STATEMENT OF RESPONSE TO AN BORD PLEANÁLA'S CONSULTATION OPINION

AMIL Properties Ltd.

IN RESPECT OF A
PROPOSED RESIDENTIAL DEVELOPMENT
GOREY, CO. WEXFORD

February 2019

Figure 2.1 – Connectivity and Permeability

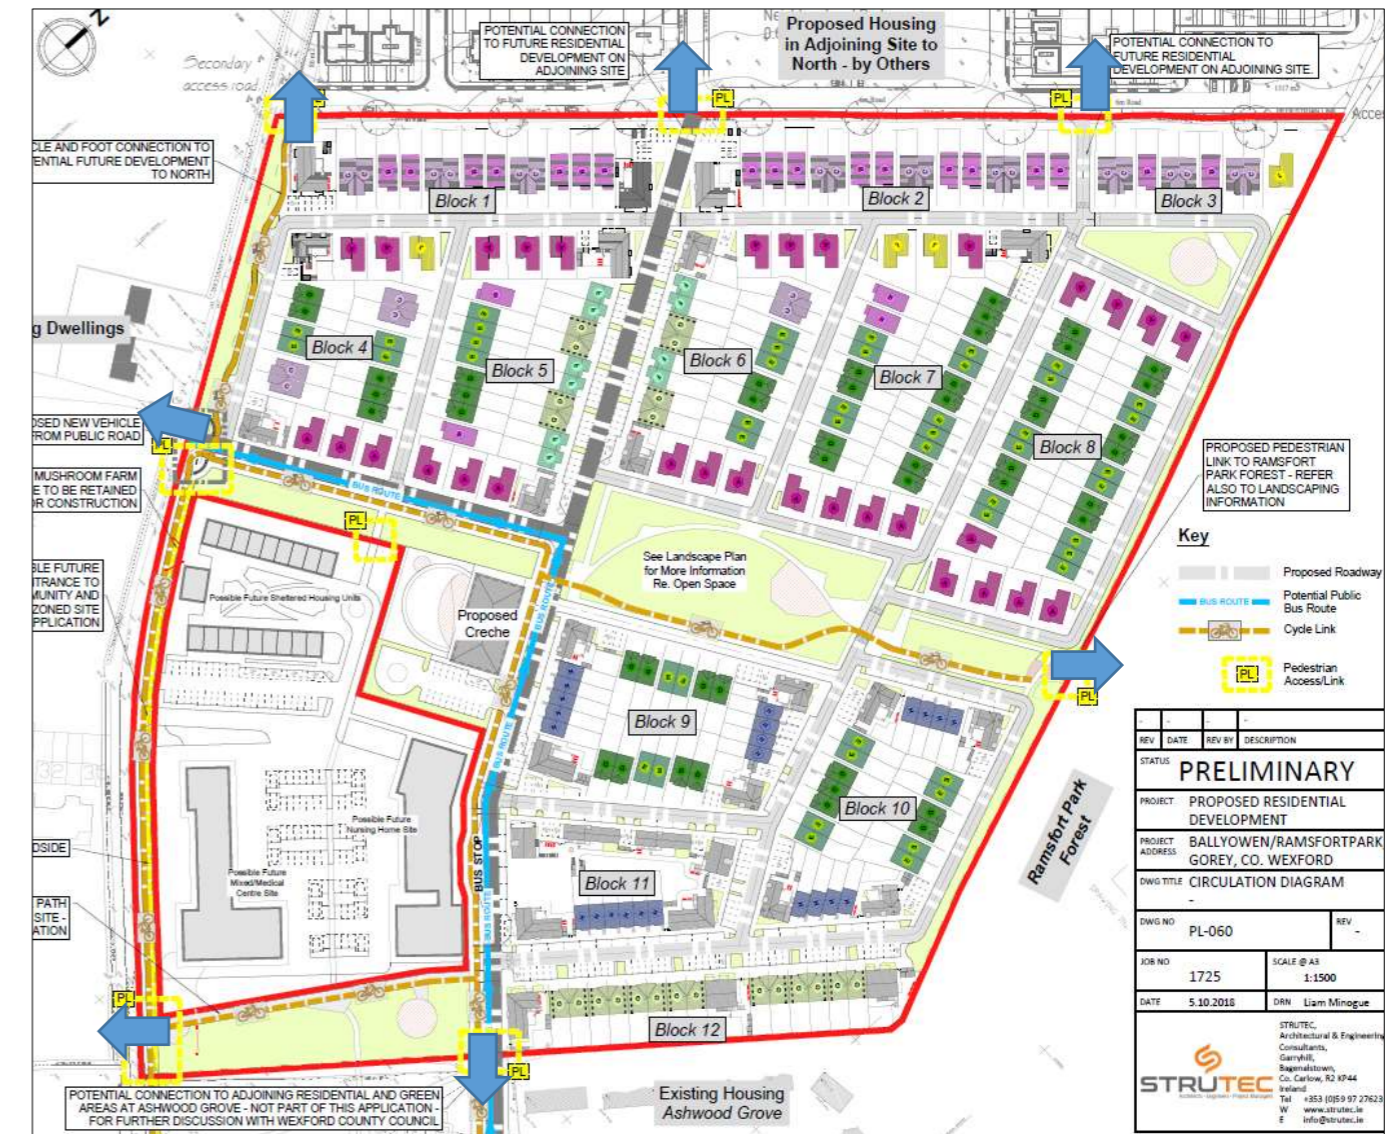
“Further consideration/clarification of the documents as they relate to the provision of connections (vehicular and pedestrian/cyclists) through the site in particular to the residential lands north of the site and the public open space lands to the south of the development site. Consideration should be given to the proposed layout of the residential scheme to the south adjacent to the open space lands and the potential for a vehicular access at this location in the future. The further consideration of this issue may require an amendment to the documents and/or design proposals submitted.”

2.3 In relation to item no. 2 referred to above, the scheme has been amended by the Design Team. The proposal now includes the provision of an additional vehicular and cyclist connection, located in the north eastern portion of the subject land to the residential zoned lands to the north. In addition, the proposed layout now includes a cyclist/pedestrian connection, located immediately within the western boundary, which will be built up to the northern boundary. This will allow for future connections to the lands to the north. Our client and design team have been in contact with the adjoining landowner and have discussed the proposals, including the boundary treatment along the northern boundary (and a letter of consent is enclosed).

2.4 Drawing PL-060, prepared by Strutec Architects shows the pedestrian, cyclist and vehicular permeability through the site.

2.5 The permeability of the southern boundary has been improved and now includes vehicular and cyclist access (cyclist access previously proposed). The open space has been designed to integrate with the existing open space to the south, and an indicative layout of the adjoining open space lands is provided. These works, located outside the application boundary, would be undertaken by the Council.

Figure 2.3 – Section through central open space

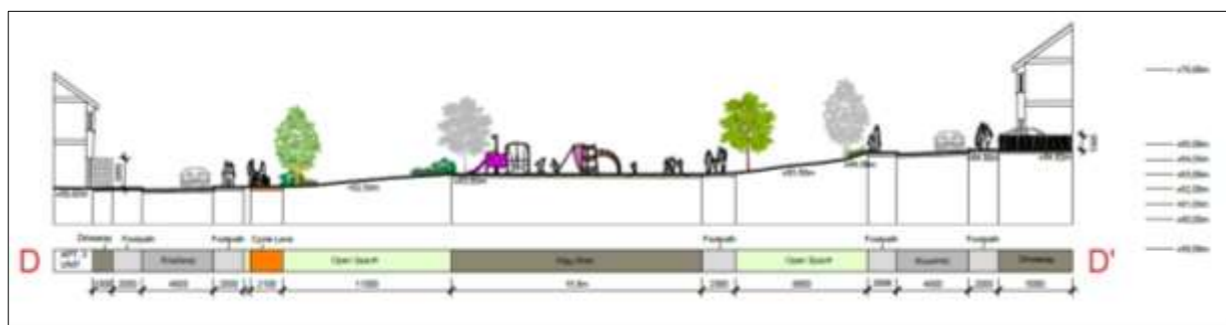
“Further consideration/clarification of documents as they relate to the functionality and quantum of open space proposed and the distribution of and connections to public open space areas. Consideration should also be given to the passive surveillance and level changes across the public open space areas. The further consideration of this issue may require an amendment to the documents and/or design proposals submitted.”

2.21 With regard to the passive surveillance of open spaces, the design provides for substantial overlooking of open spaces within the scheme design. The objective of the design team has been for dwellings to address the greens (pocket parks) and neighbourhood parks as much as possible. This over-arching design principle will ensure that there is a high degree of passive surveillance throughout the proposed development, providing a safe and secure environment for future residents and visitors to the area, using all the attractive green spaces throughout the scheme.

2.22 It is also noted that the design of the development includes apartment buildings located on the corners of the residential blocks which provide additional presence and overlooking of the opens space areas.

Figure 2.6 – Agreed Route for Wastewater Infrastructure

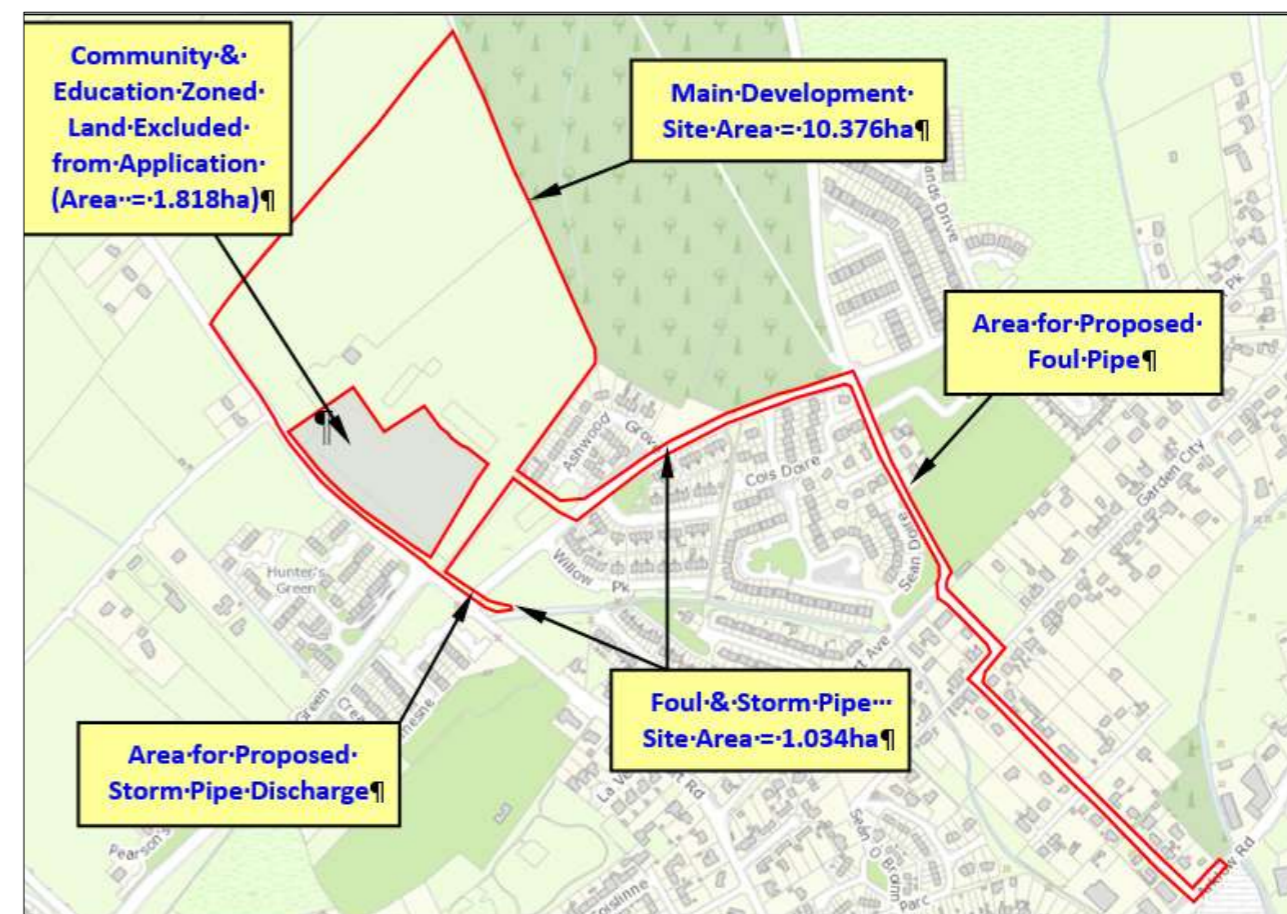
“Further consideration/clarification of the documents as they relate to the required extension in the wastewater infrastructural network to serve the proposed development. The prospective applicant is advised to liaise with Irish Water with regard to the nature of works required to address any proposed extension/upgrade to the network to facilitate the development, whether planning permission is required for such works and likely timing for securing such permissions where required. The documentation at application stage should provide details with regard to the network extensions including layout and design details and the timelines involved relative to the construction and completion of the proposed development.”

2.33 In response to the above item, we refer the Board to the Statement of Design Acceptance (Customer Reference No. 8042651993) dated the 6th of February 2019 which is enclosed with the SHD application.

2.35 The proposed foul water sewer layout is shown on Drawing Numbers IE1505-001-C to IE1505-006-C. It is proposed to drain all dwellings including the possible future development of the area zoned for ‘Community and Education’ within the site via a sewer located within the proposed roads and pavements and discharge to an existing 525mm diameter Irish Water sewer located approximately 1km south of the site boundary on the Arklow Road (R772) and opposite the Lidl supermarket.

2.37 The proposed pipe route is located with the public road for the majority of the route. There is one section which traverses an area of open space which is in the ownership of Wexford County Council.

Figure 3.1 – 879 Bus Route (source: TFI)

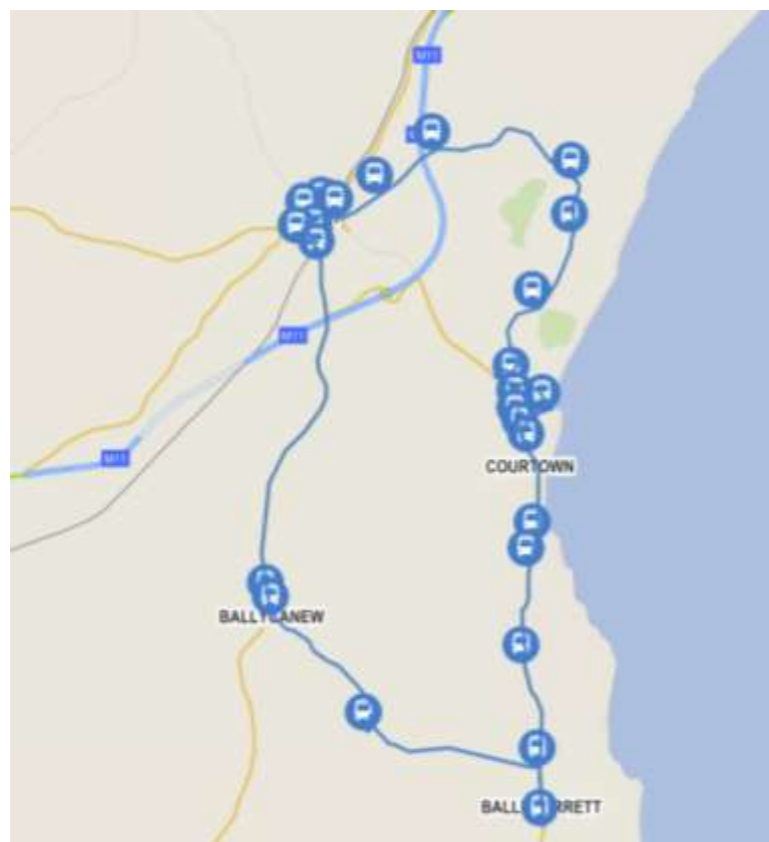
“A site layout plan indicating pedestrian and cycle connections through the development lands to existing and proposed transport modes in the vicinity. Connections from the residential lands north of the site through the subject site should also be indicated.”

3.13 In response to this item we refer the Board to drawing no. PL-060 prepared by Strutec Architects (see section 2.3 above), which shows the pedestrian and cycle connections through the development lands. The layout of the Avenue can accommodate a local bus route which currently operates in the area (no. 879), and which connects to the Gorey Railway station.

3.14 Additional services (Bus Eireann) and private buses are located on the Main street to the south of the development linking the lands to Dublin City, Dublin Airport and Wexford town. Additional cyclist and pedestrian connections are provided to the residential lands to the north and also to the south.
